# PERMIT

A REPAIR

## ON-SITE SEWAGE DISPOSAL SYSTEM HOWARD COUNTY HEALTH DEPARTMENT BUREAU OF ENVIRONMENTAL HEALTH

ADDRESS: 2879 Florence Road

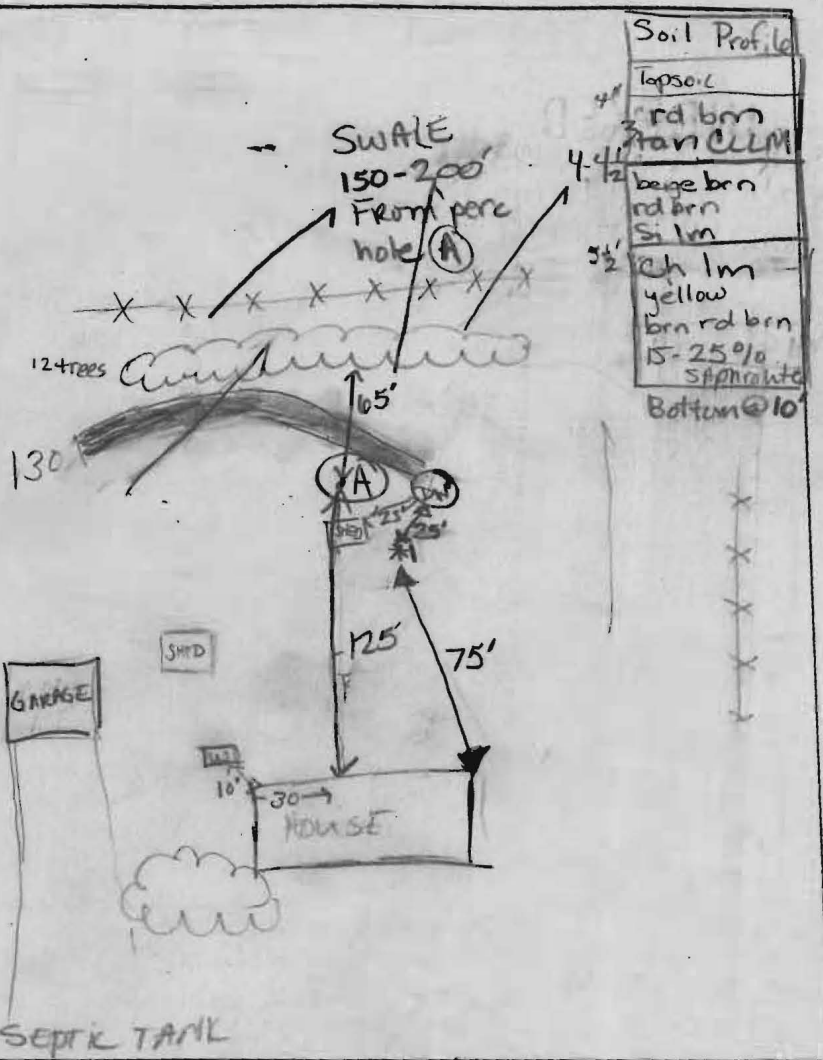
PRE-CONSTRUCTION INSPECTION: Tie trench into ex. dw. 1x125' trench. 6 min

perc rate @ 5'8". (KG/RP)

INSPECTION COMMENTS: 8-24-01 10:30 AM Trench dug. Reinspect for final (KG) 8-24-01 @ 1:45 OK to place gravel & pipe (KG) Trench complete. New sd 40 lin. between old st. & old dry well (Now a sealed S.T.) with 7" Baffles. OK to cover all work RP 8/28/01
